RE: Project No. 405-81  
Logan County  
County Road 39

CHANGE ORDER

Proj. No. 405-81  
Logan County  
CR 29  
Change Order No. 1

PROJECT 405 (80)  
PROPOSE GRADE CHANGE

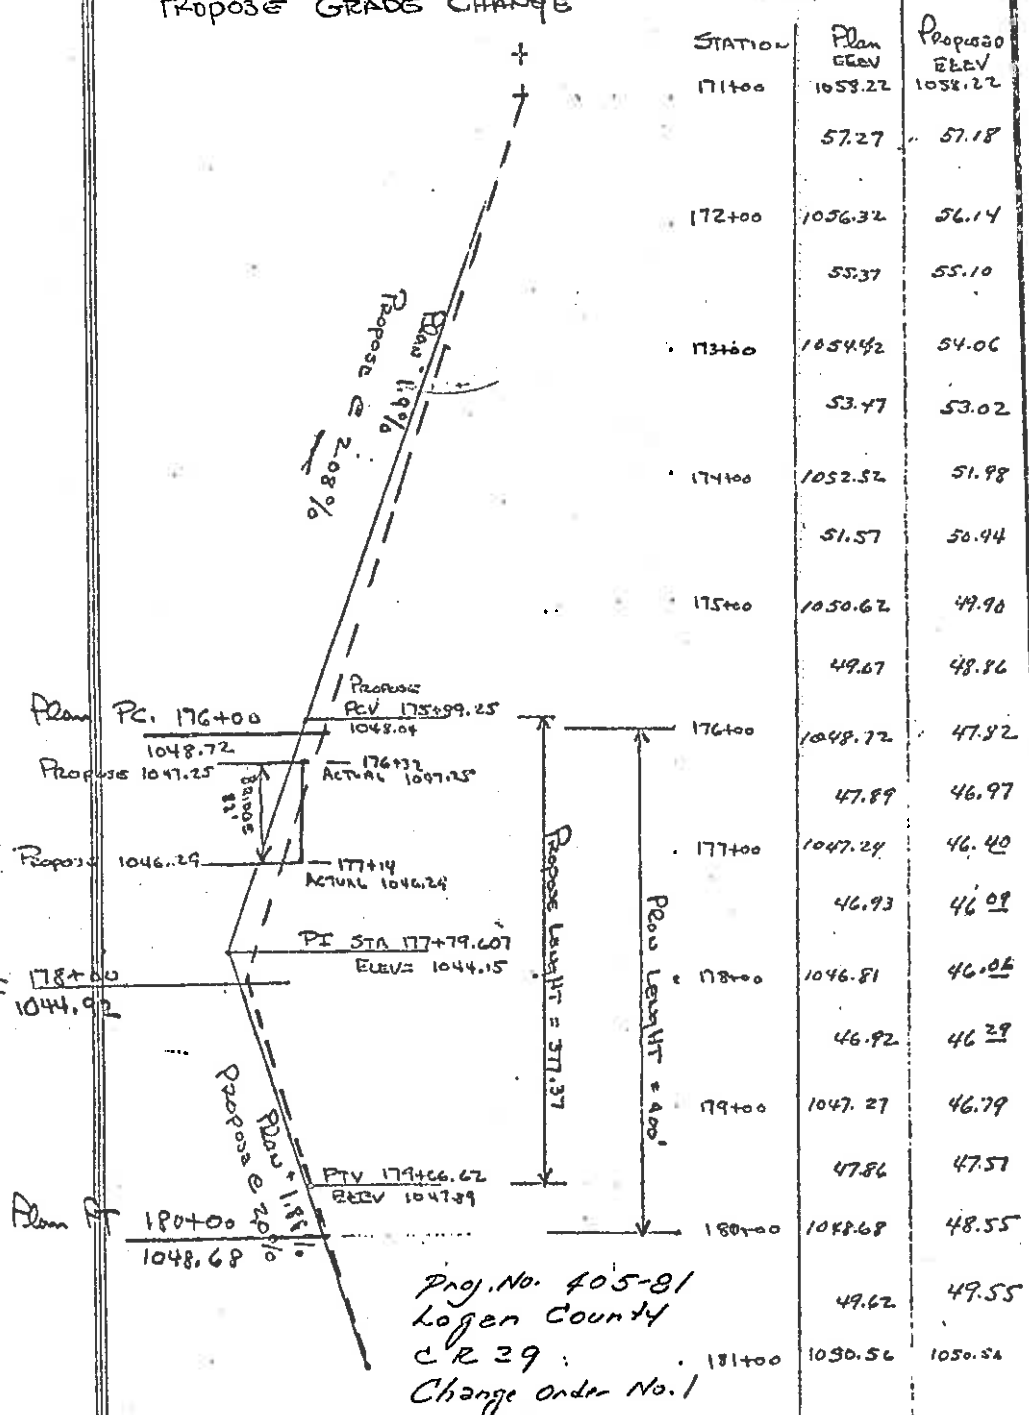
The roadway and approach pavement are to be constructed to the revised profile elevations as shown on the attached sheet. This revised profile will result in a nonperformance of embankment. The adjustments in earthwork and any other quantities as may be effected by the revised profile grade will be adjusted in final measurements.

STATION	Plan ELEV	Proposed ELEV
171+00	1058.22	1058.22
	57.27	57.18
172+00	1056.34	56.14
	55.37	55.10
173+00	1054.42	54.06
	53.47	53.02
174+00	1052.52	51.98
	51.57	50.94
175+00	1050.62	49.90
	49.67	48.86
176+00	1048.72	47.82
	47.89	46.97
177+00	1047.24	46.40
	46.93	46.09
178+00	1046.81	46.05
	46.92	46.29
179+00	1047.27	46.79
	47.86	47.57
180+00	1048.68	48.55
	49.62	49.55
181+00	1050.56	1050.54

PROJECT 405 (80)  
 PROPOSE GRADE CHANGE

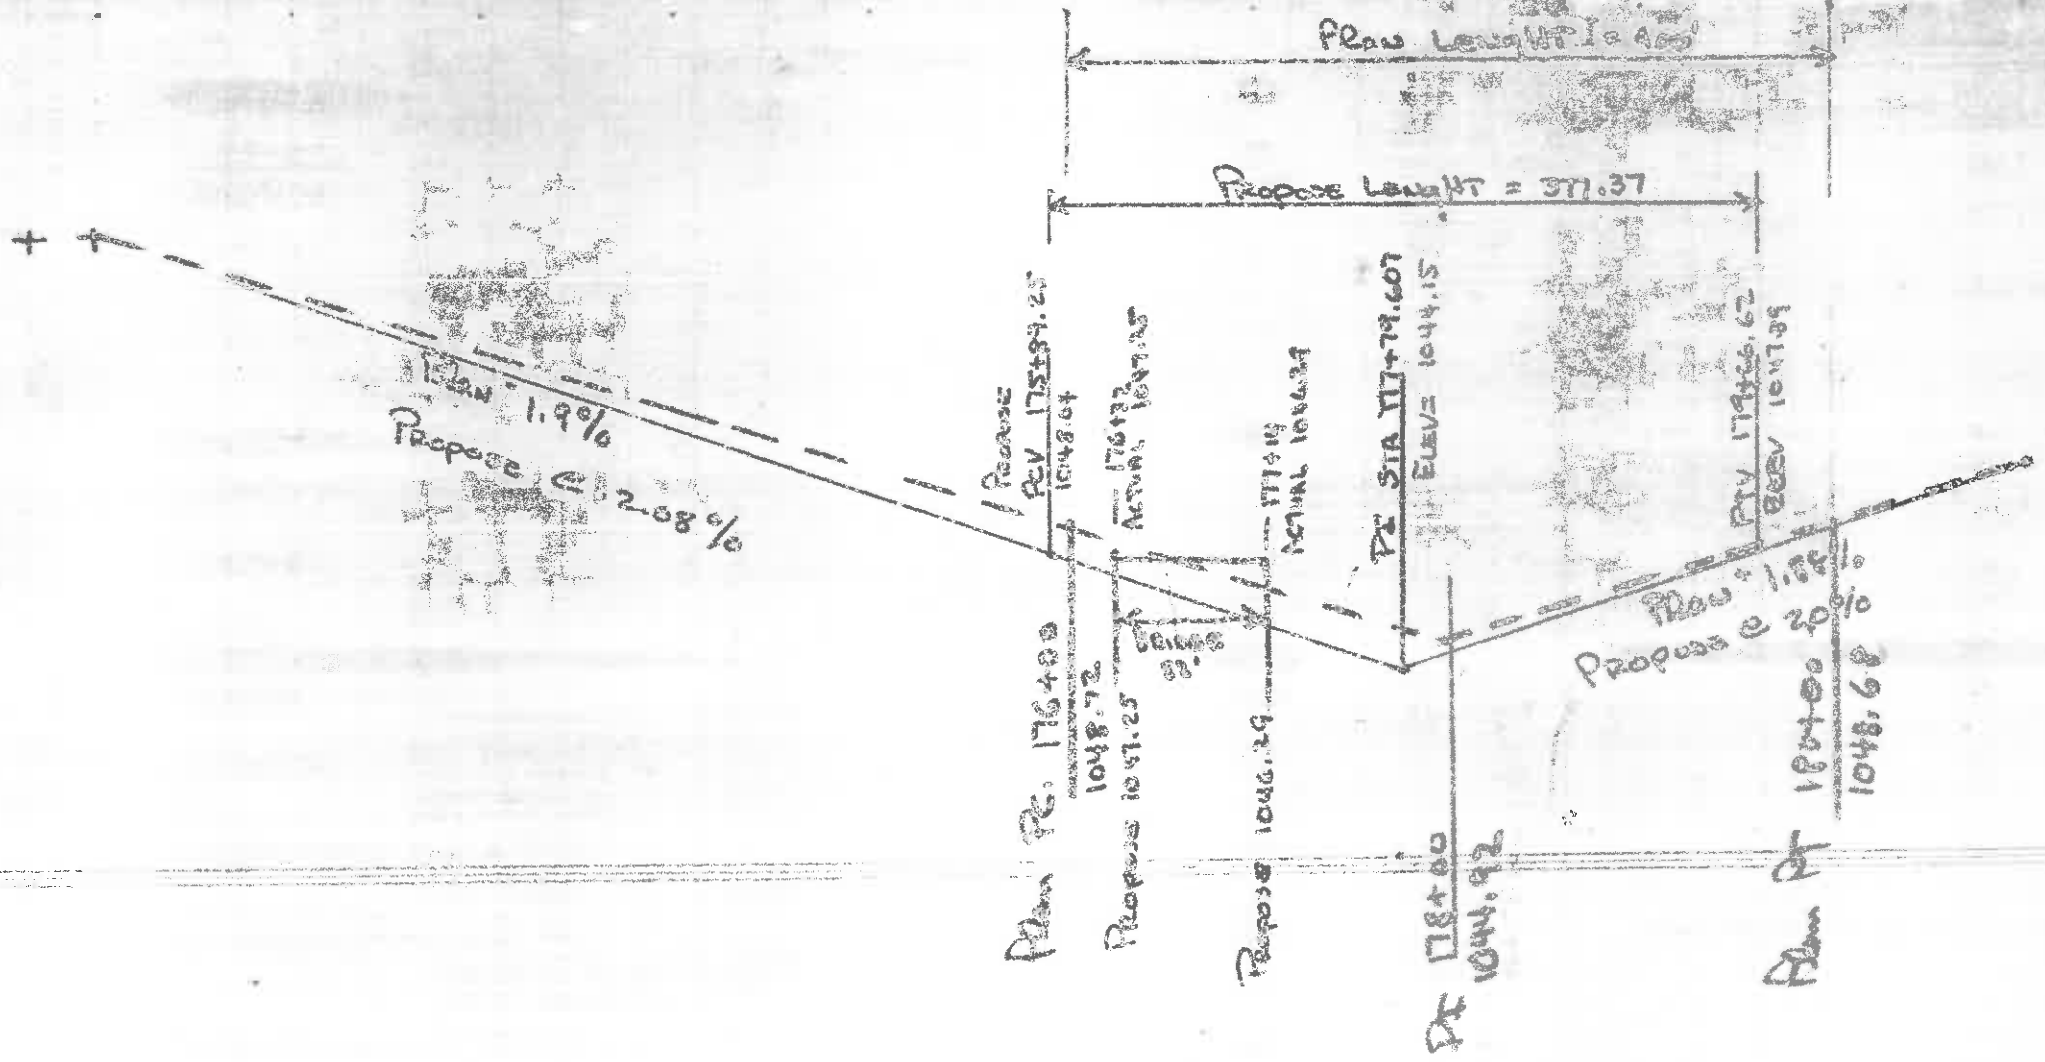
The Contractor established a supplementary bench mark that was used for construction of Bridge No LOG-C R 39-4.98. However, thru an error, an incorrect elevation was assigned to this bench mark. This error, which was not discovered until the bridge was completed, resulted in the bridge being built at an elevation lower than the proposed plan elevation.

After reviewing the elevation of the structure as built, it has been determined that this will not result in any detrimental effect to the Project and that the structure may remain in place. A copy of the letter of concurrence from the County Engineer is attached.

STATION	Plan ELEV	Propose ELEV
171+00	1058.22	1058.72
172+00	57.27	57.12
173+00	1036.32	56.11
173+00	53.37	55.16
174+00	1054.42	54.0
174+00	53.47	53.0
174+00	1052.52	51.5
175+00	51.57	50.4
175+00	1050.62	49.5
176+00	49.67	48.1
176+00	1048.72	47.0
177+00	47.89	46.5
177+00	1047.29	46.4
177+00	46.93	46.5
178+00	1046.81	46.5
178+00	46.92	46.5
179+00	1047.37	46.7
179+00	47.86	47.5
180+00	1046.88	48.5
181+00	49.62	49.5
181+00	1050.56	1050.52

Plan 1.9%  
 Propose @ 2.08%

Plan PC: 176+00  
 1048.72  
 Propose 1047.25

Plan PT 180+00  
 1048.68  
 Propose @ 1.35%  
 Propose @ 2.0%
